STATE OF NORTH CAROLINA
DEPARTMENT OF TRANSPORTATION

May 1, 2020

Subject: Revised Modification Request for the Section 404 Individual Permit and Section 401 Water Quality Certification for the proposed Havelock Bypass in Craven County. TIP No. R-1015. Debit \$ 570 from WBS 34360.1.2

BUFFER DRAWING SHEET 13 OF 20

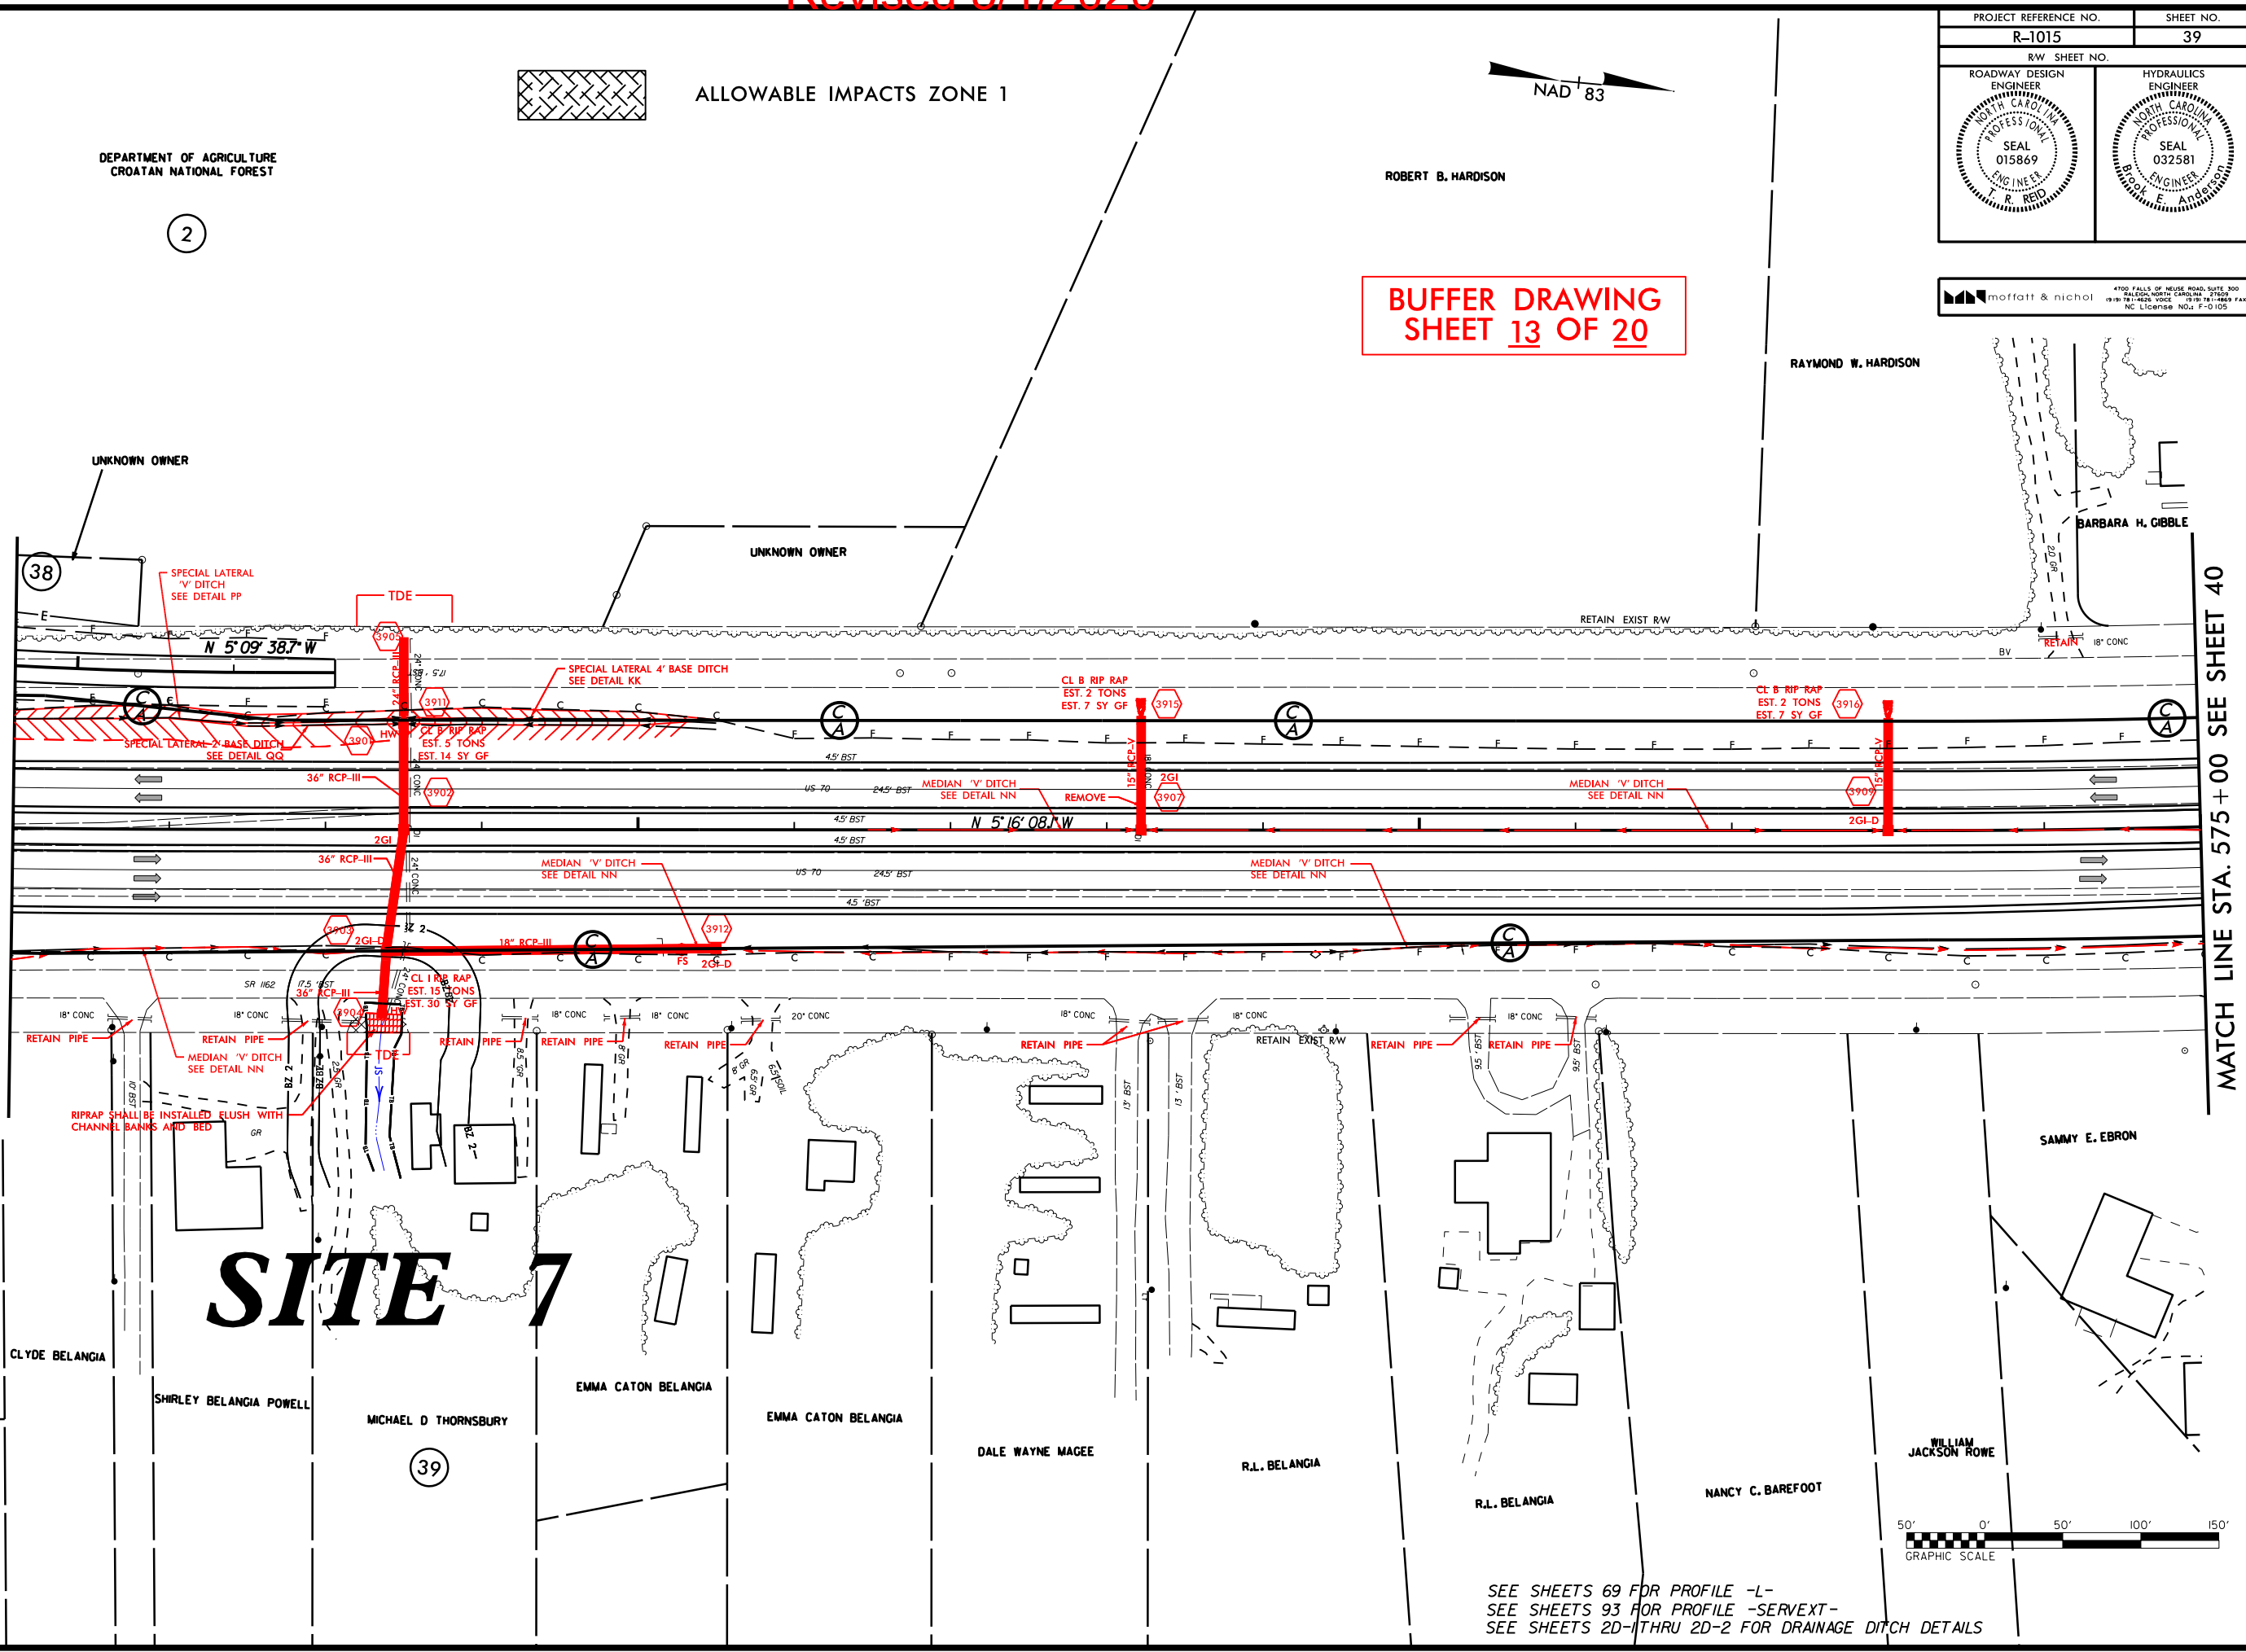
- Site 7 (buffer sheet 13) reduced Allowable Zone 1 impacts by 282 s.f. The pipe was shortened to eliminate easement on a property, and a headwall added.
- Summary updated (buffer sheet 18 & 19). Allowable Zone 1 impacts are reduced from 42,810 s.f. to 42,529 s.f. due to the changes at Site 7.
